Department of Environmental Protection

January 26, 1995

DRAFT

Re: Southeast Landfill, Hillsborough County
Operation Permit Renewal
Pending Permit No.: SO29-256427

DRAWN BY: BKB	CHECKED BY: BKB	DATE: 03-03-94
FILE NO. 93-029	APPROVED BY <i>[Signature]</i>	FIGURE NO. 12

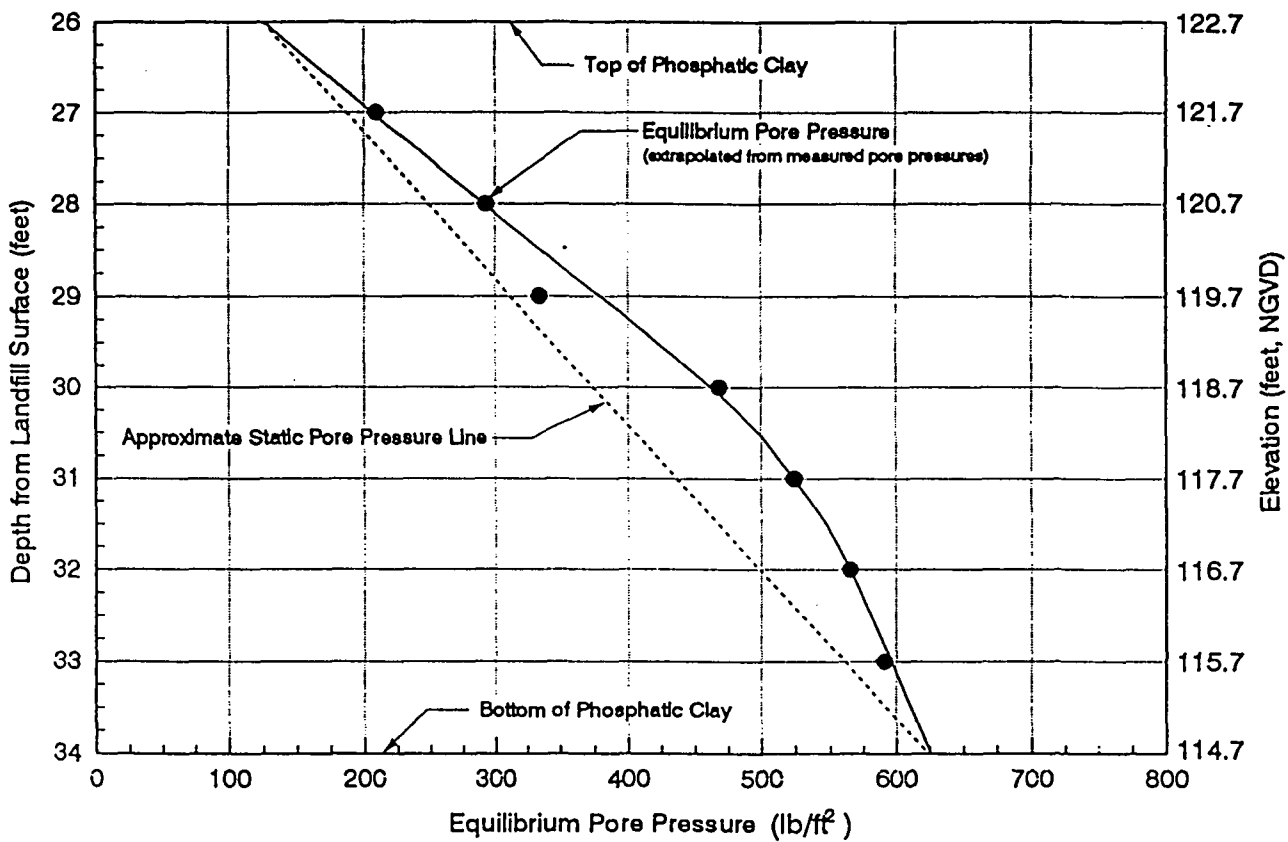
3. Please explain how the 3.6 feet head was derived from Ardaman's Figures 12 and 13. Ardaman's reports do not explain how the static pore pressure line was estimated as shown in Figures 12 and 13 or why the leachate level was assumed to be 2 feet rather than the actual depth of leachate observed at the time of testing. Did Ardaman measure and record the actual depth of leachate at each test location? Figures 12 and 13 represent conditions that exists at two specific locations, but neither represents the worst case. The test location in Phase I has not been loaded for more than 8 years, has a clay thickness of only 3.5 feet, and represents the existing worst case condition for hydraulic head over the liner. Please provide an additional figure such as Figures 12 and 13 that represents the expected worst case condition for hydraulic head at the test location in Phase I. Since loading in Phase I has been delayed for more than the recommended "7 year waiting period", the additional figure is requested to represent conditions that would exist at the latest time of placing an additional lift in Phase I. The additional figure should be supported by the equations used for calculating the hydraulic head over the liner as a result of depth of leachate.
